# Memo

DP07-0170

DVP07-0193

932 - 934 BORDEN AVE.

SITE PLAN

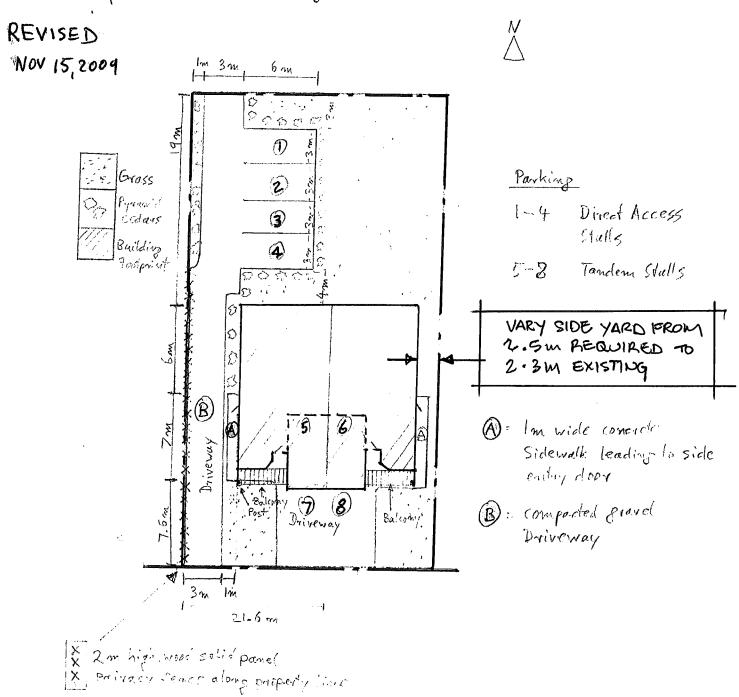
A minimum of six off-street vehicle parking spaces are required. The parking modules must meet bylaw requirements. The rear yard parking area is to be designed so as to allow vehicles to turn-around on-site and exit the site in a forward direction.

Additionally, given that the parking requirements will utilize a significant portion of the usable open space on the site, the outdoor functionality of the units is compromised. In response, the applicant has provided balcony/upper deck space for both upper units to create additional quality open living space.

Proposed direct access parking Stalls

LAUDSCAPE PLAN

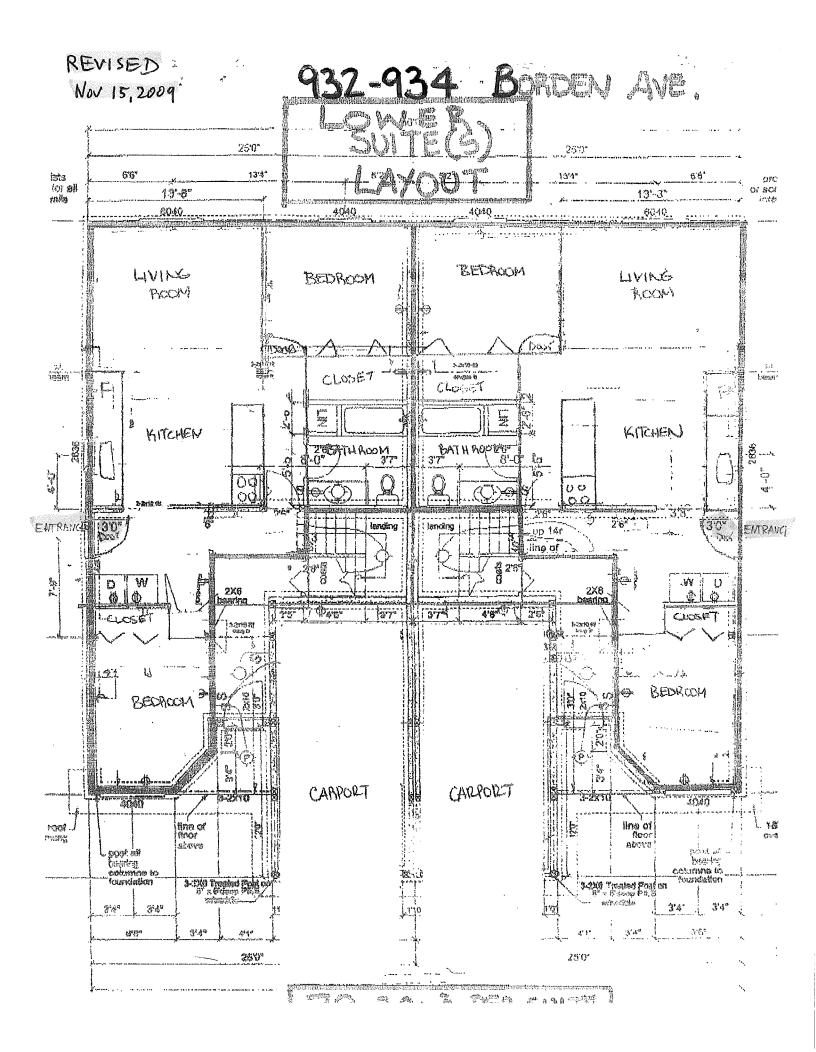
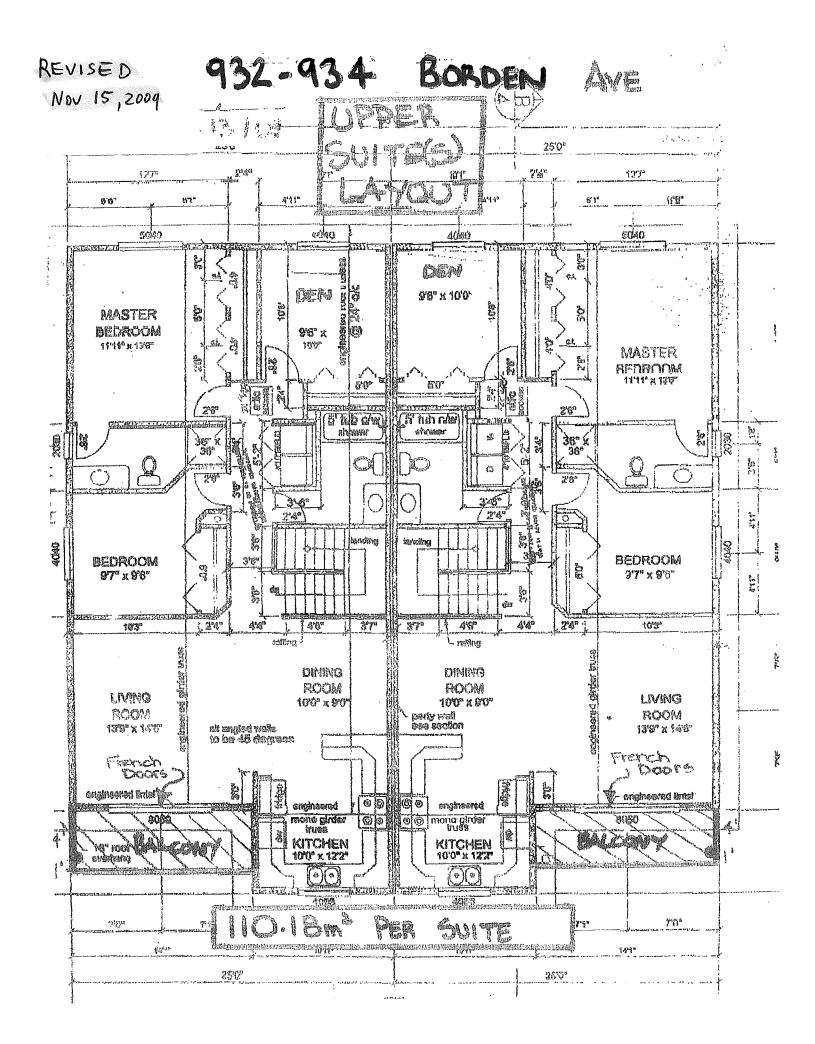
The applicant has modestly addressed some of the site and design concerns raised by staff. Building plans have been amended to add a deck to each of the upper level units to provide private open space for the upper level units. As well, the driveway to access the new rear yard parking stalls has been reconfigured to move it over towards the property line in order to retain the existing sidewalk that provides access to the lower level unit located on the west side of the building.

Privacy fence along properly line

REVISED NOV 15, 2009 Im 3m 6 m PODDE 0 Parking Grass (Z) Pyramid Direct Access 1-4 3 Cedars Stalls Building Toolprisit 4 5-8 Tandem Stalls A = Im wide concrete 138 Sidewalk leading to side entry door Driveway B = compacted gravel Balcohy! Driveway 3 m Im 21-6-0 2 m high, wood solid panel
